Repair Notice

916-2

The Peterbilt SmartAir System may shut down without warning.

Subject: FRN 916-2: Models 579/567 Peterbilt SmartAir No-Idle System Software Issue

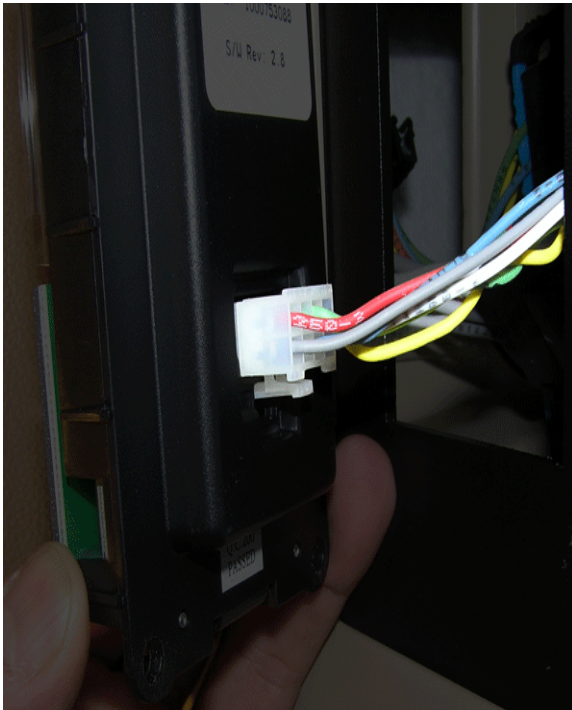
4. Check the software revision number on the back of the control panel:

5. If the revision number is 2.9 or higher, reinstall the control unit.

- If the software revision number is 2.8, replace the control unit with a control unit loaded with software revision 2.9 or higher.

1. Use a non-marring trim removal tool to remove the SmartAir control panel cover.

2. Remove the four mounting screws.

3. Disconnect the electrical connector from the back of the SmartAir control panel.

6. Installation is the reverse of removal.
